Access Compliance Report

Public Rights-of-Way

(Curb Ramps)

Intersection ID: 11184	Main Street: OAK_FOREST_DR	Cross Street: SLAGLE_DR	Location: NW
ADA ID: A93DF76741F8	Ramp Type: Para	Initial Pass/Fail: Fail	Overall Compliance: No
Severity Score: 12.5			
Codes/Mitigation Info/Possible Solution		Field Measurements/Component Compliance

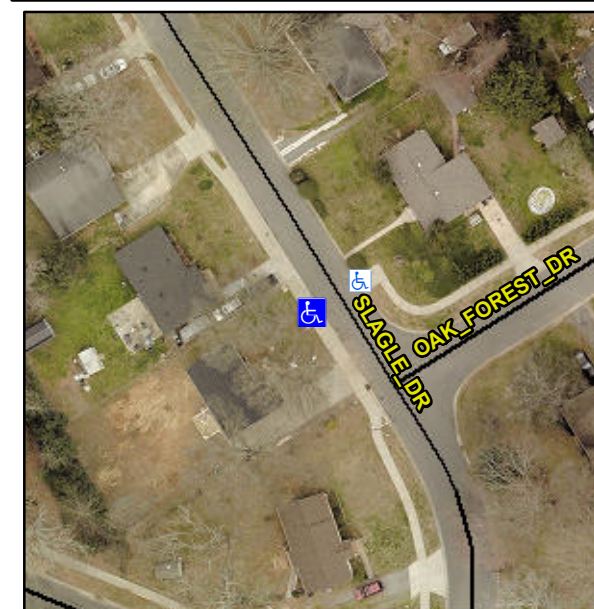
RT RP < 5%

R304.3.2

Remove & Replace Entire Ramp.
